REMARKS

ANNOTATED MARKED-UP DRAWINGS

Fig 4
(Related Art)

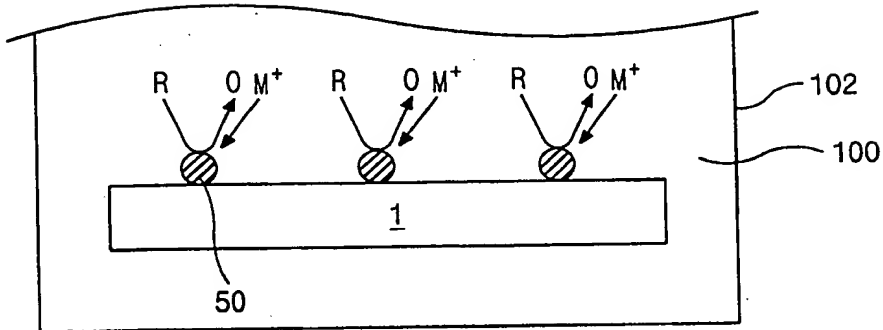
The Examiner objects to the drawings, requesting that Figure 4 include the label "Related Art." Applicant submits a marked-up version of Figure 4 which indicates the inclusion of the legend "Related Art". The Examiner is respectfully requested to withdraw the objection.
